RE: Former Exxon RAS #7-3035/4501 Sonoma Highway, Santa Rosa, California.

Subject: Addendum to Work Plan for Additional Site Assessment, Former Exxon Service
Station 7-3035, 4501 Sonoma Highway, Santa Rosa, California

**California Regional Water Quality Control Board, North Coast Region, Case No.
1TSR295.**

**PROPOSED CPT AND MONITORING
WELL LOCATION MAP**
FORMER
EXXON SERVICE STATION 7-3035
4501 Sonoma Highway
Santa Rosa, California

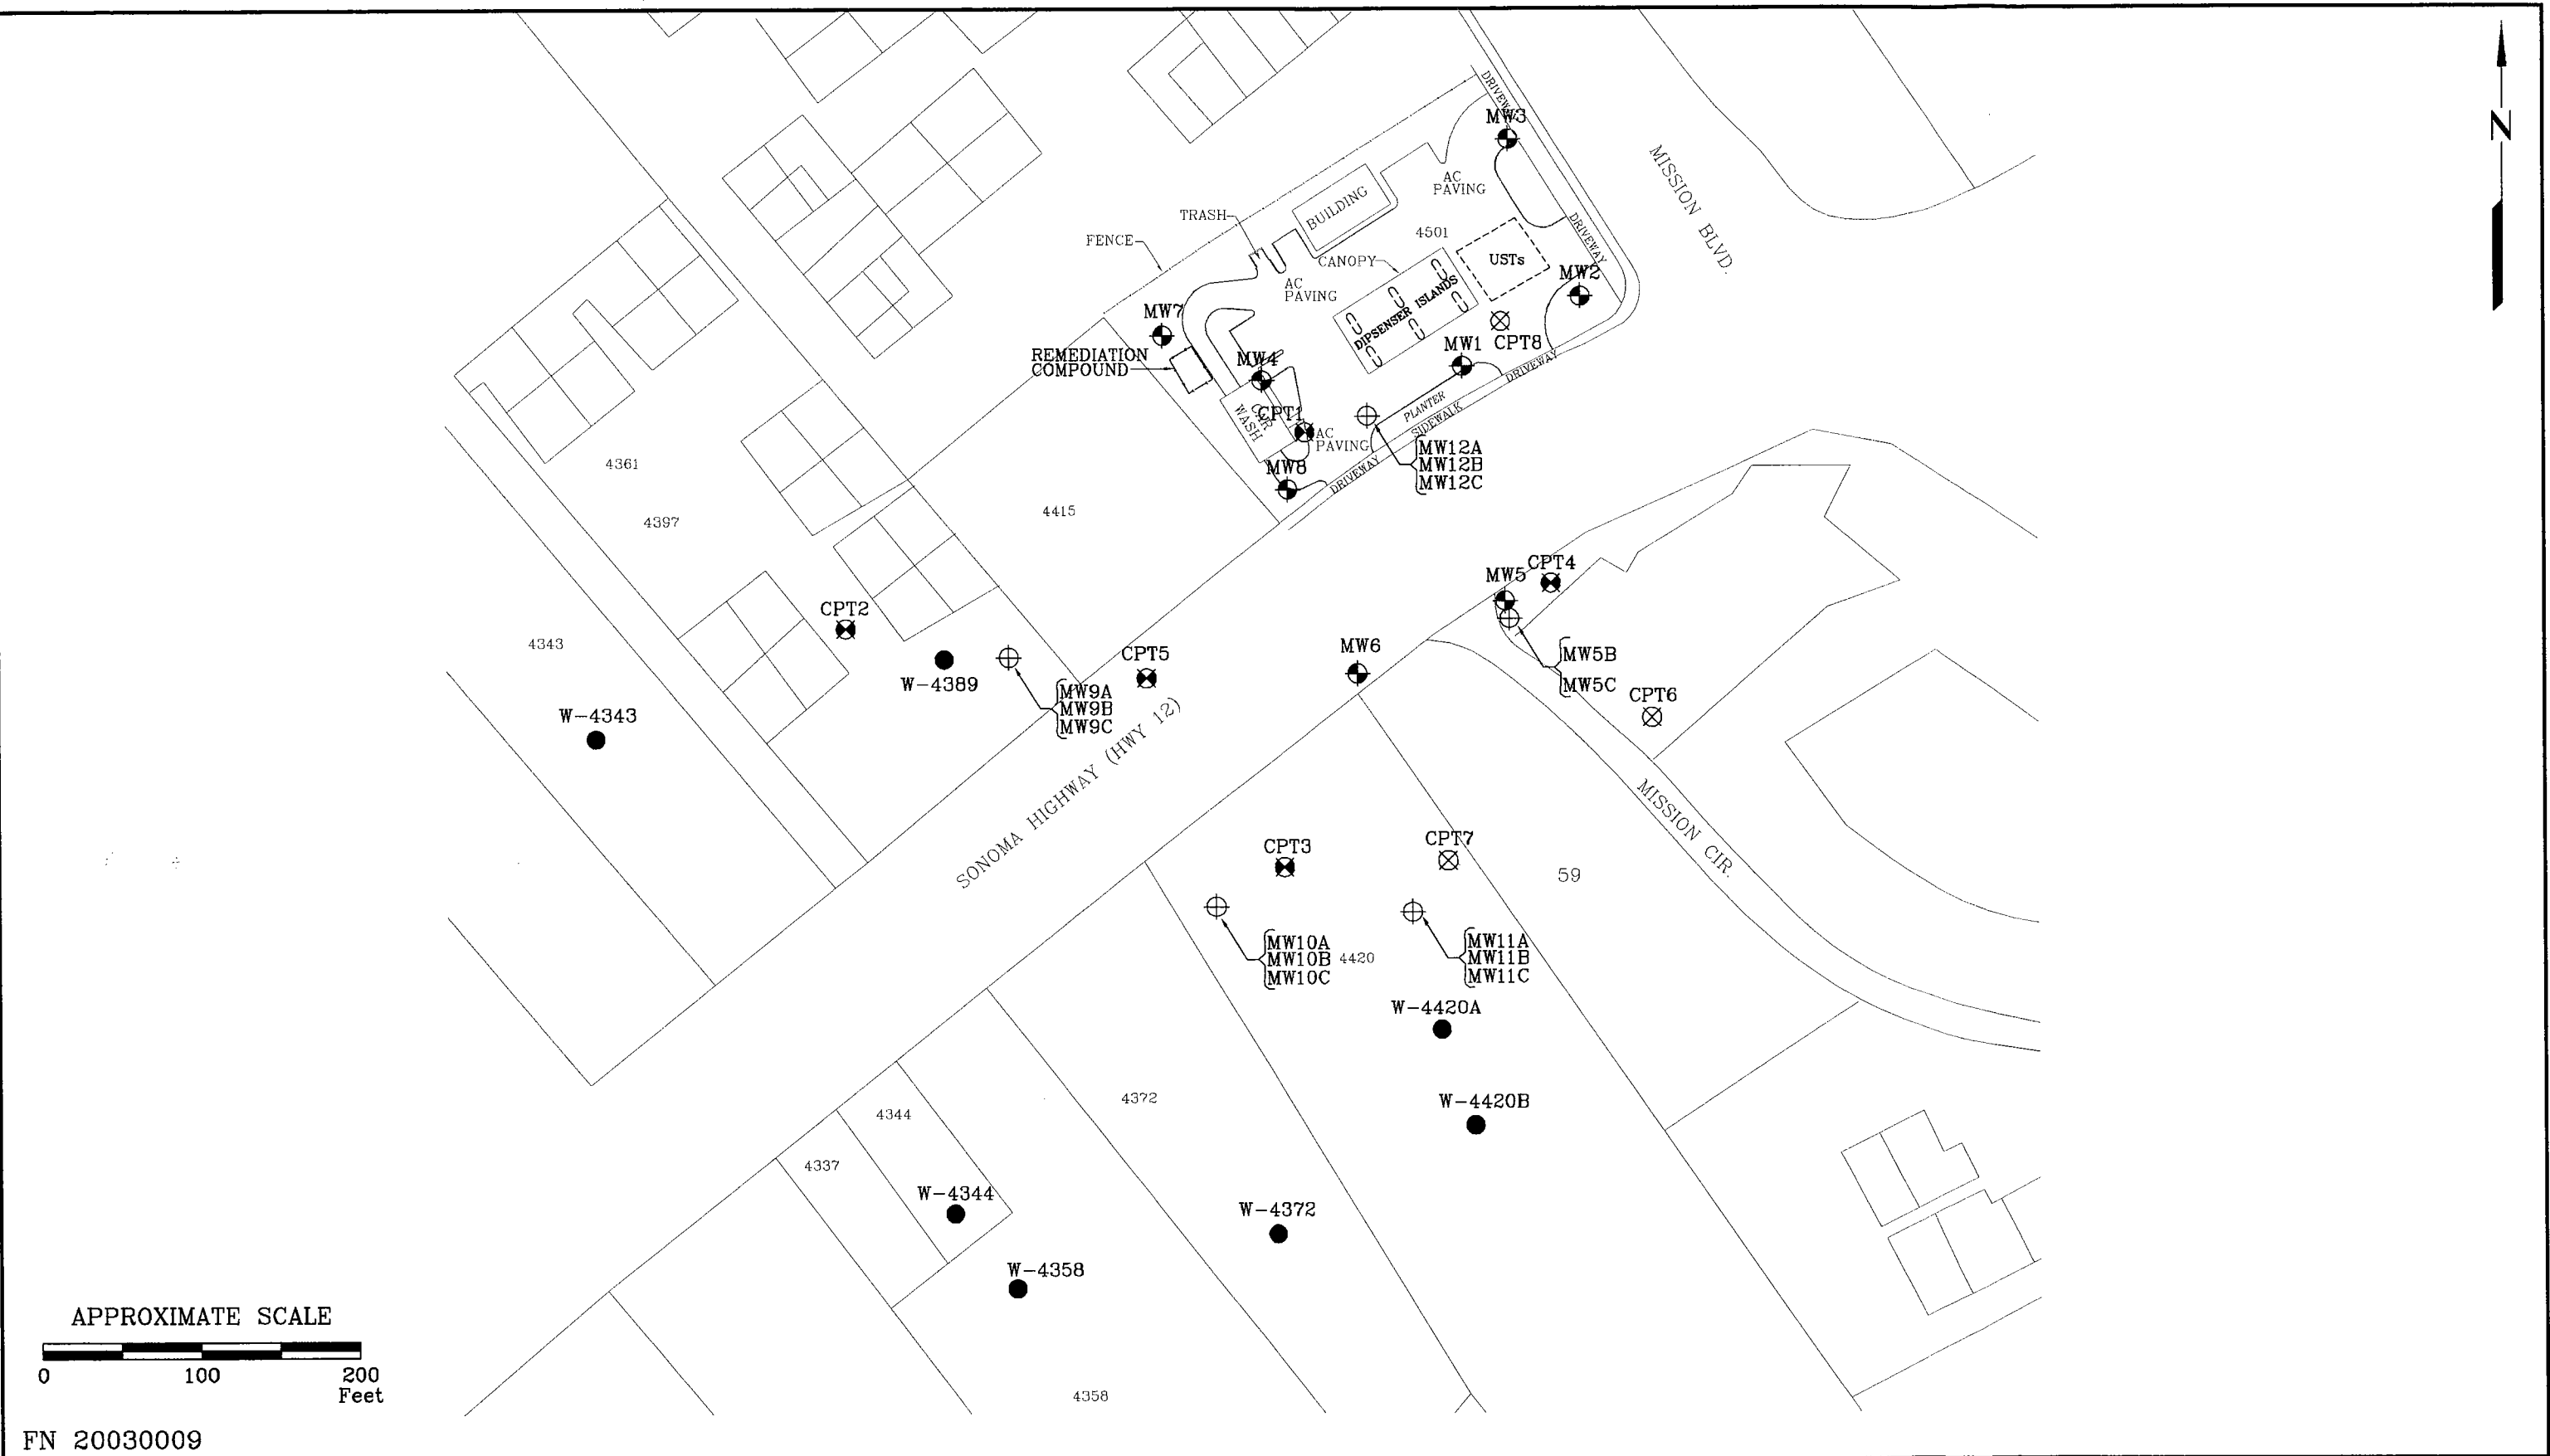
ERI proposes to advance an additional CPT/HP boring (CPT8) to approximately 80 feet below ground surface (fbgs) at the location shown on Plate 1. Results of previous depth-discrete groundwater sampling from the CPT investigations performed in August and September 2004 indicate that the highest dissolved hydrocarbon concentrations occur in off-site boring CPT4 at depths of 36 and 42 fbgs. The proposed additional boring is located to assess the vertical distribution of dissolved hydrocarbons on site downgradient of the underground storage tanks and upgradient of boring CPT4. ERI will collect soil and depth-discrete groundwater samples from the boring, and submit the samples for laboratory analysis as proposed in the Work Plan.
